Mr. Larry Borum, Chief  
Gas Pipeline Safety Division  
Tennessee Regulatory Authority  
460 James Robertson Parkway  
Nashville, TN 37243-0505

Re: Docket 07-00251, Petition of Atmos Energy Corporation  
for a Waiver to Permit the Limited Use of Polyethylene Piping

## STANDARD TRENCH - 2" MAINS & UNDER

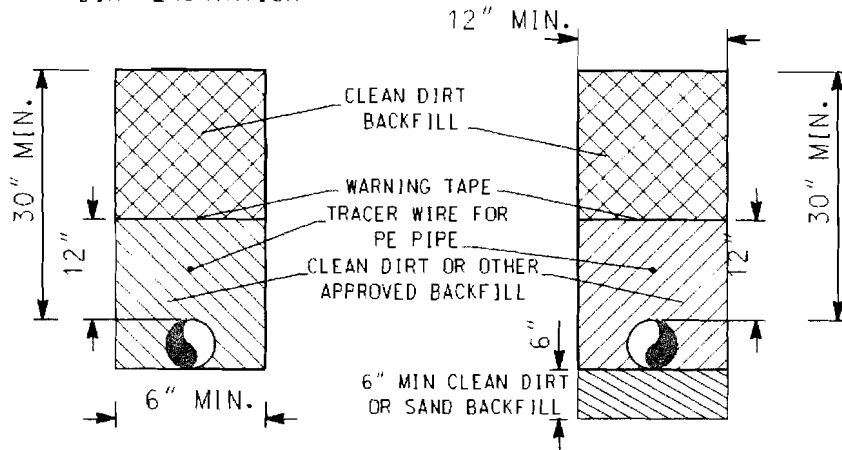
Question 6. *Can a trench detail for a typical installation be supplied to the GPSD staff?*

A typical trench detail is attached.
